# Groundwater Application Review Summary Form

Application # G- 18888

PUBLIC INTEREST REVIEW FOR GROUNDWATER APPLICATIONS

TO: Water Rights Section Date January 7, 2021  
 FROM: Groundwater Section Aurora C Bouchier  
 Reviewer's Name  
 SUBJECT: Application G- 18888 Supersedes review of May 13, 2020  
 Date of Review(s)

Water-Level Trends in Nearby Wells

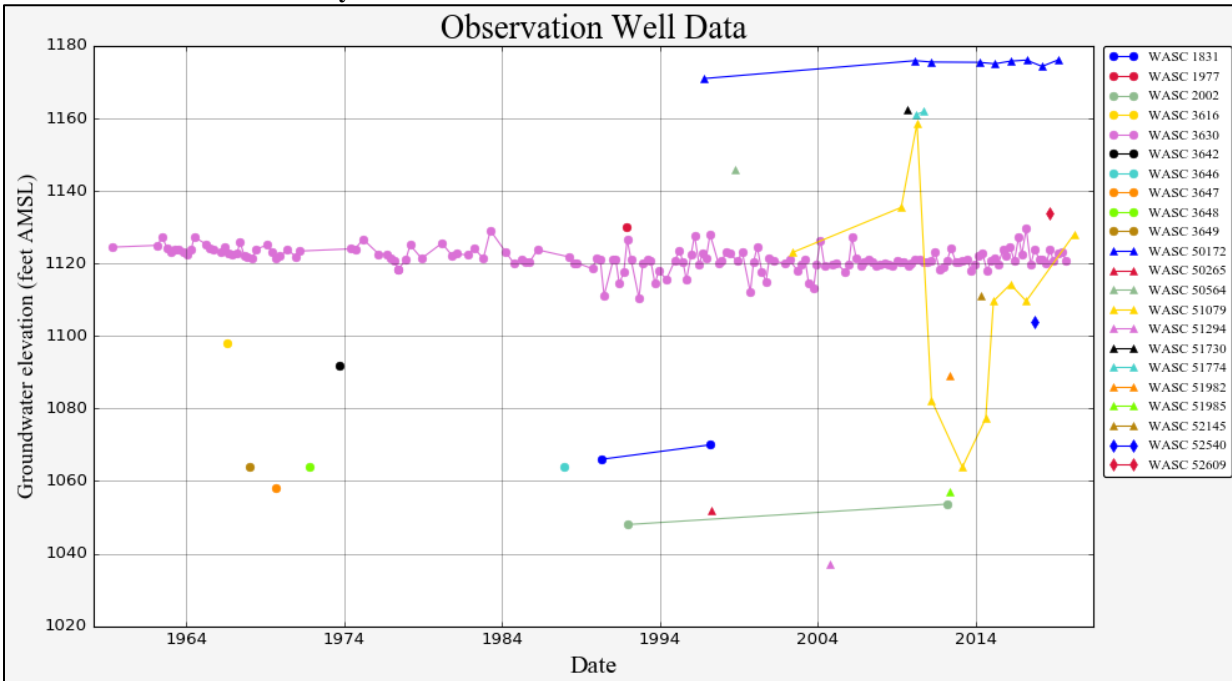
There are a number of nearby wells completed in the Dalles Formation. WASC 3630 (located on the south edge of Tygh Valley) has been monitored since the 1960's and shows no decline and a water-level coincident with nearby reaches of Tygh Creek. Two nearby wells (WASC 51079, located approximately 2 miles to the west along the north flank of Tygh Valley and WASC 51079 located approximately 1-1/2 miles on the hillsides to the northeast) have water-level permit conditions. Water-level measurements from WASC 51079 are relatively erratic, likely a response to pumping and restricted to a small locality. Aside from WASC 51079, the hydrograph for nearby wells indicates overall stable conditions at the current use.

Analytical Model for Stream Depletion of Tygh Creek

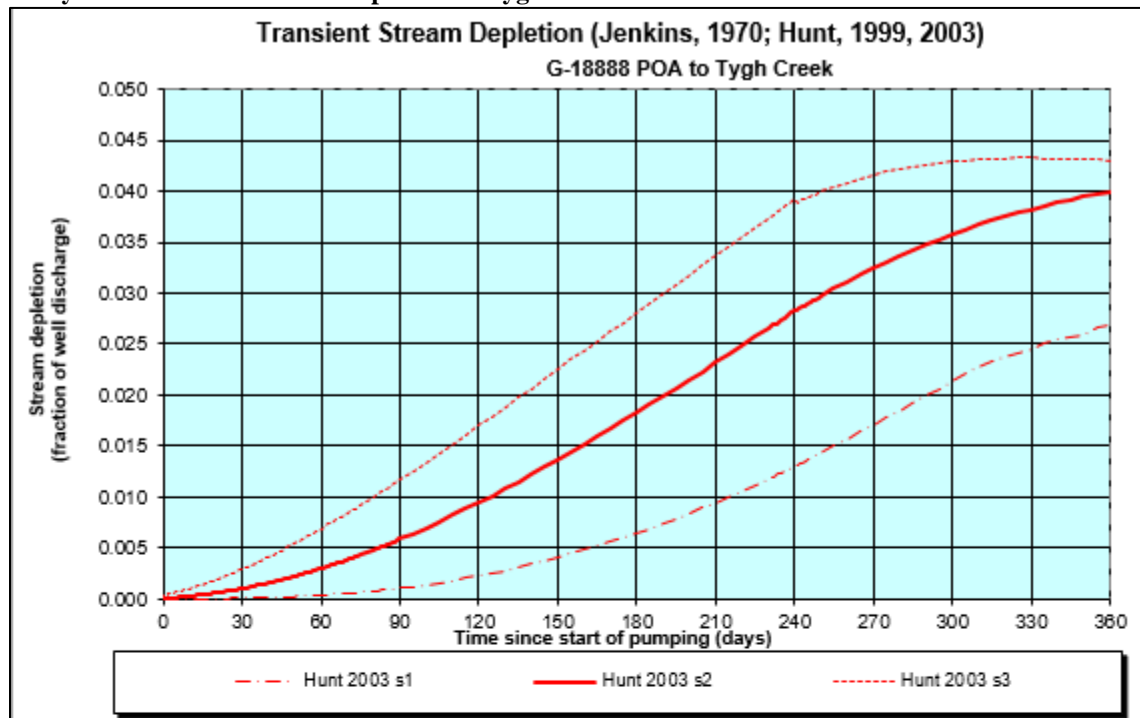
**Comments:** Interference at 30 days between the well and the surface water sources was estimated using the Hunt 2003 model. The low permeability layers below the stream bed result in an inefficient connection between the aquifer and the stream, therefore interference at 30 days should be less than 25%.

Analytical Model for Stream Depletion of White River

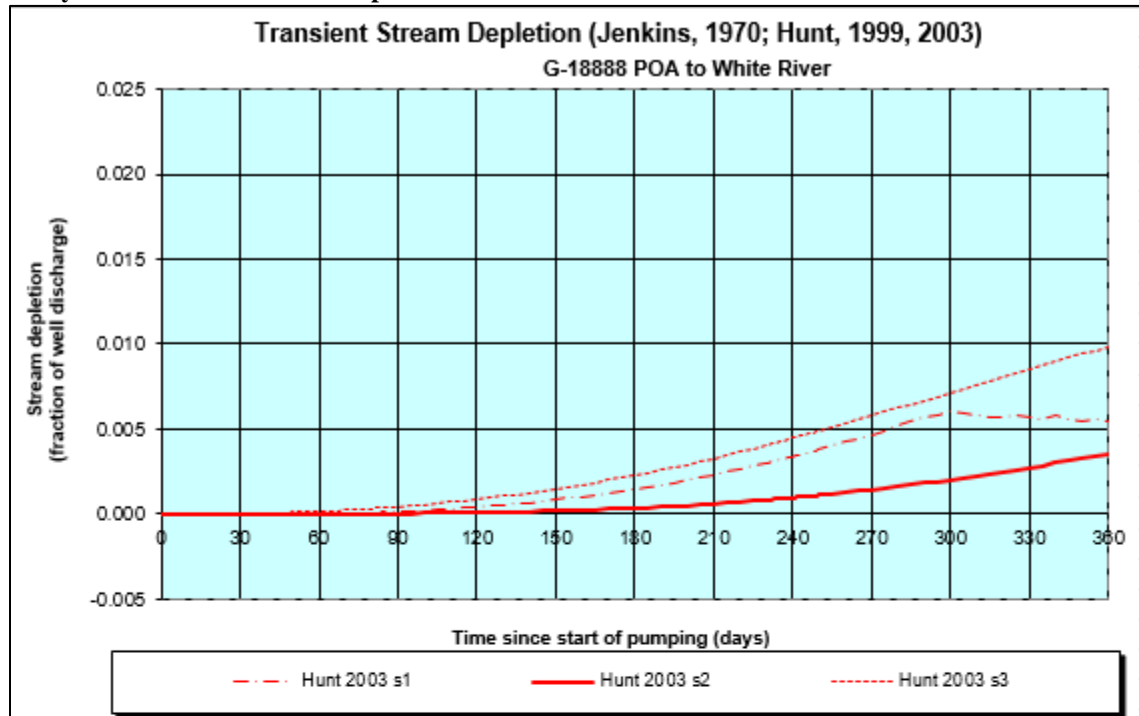
**Basis for impact evaluation:** Interference at 30 days between the well and the surface water sources was estimated using the Hunt 2003 model. Please note from the above table line (E) the largest value was 4.7 x e-7.
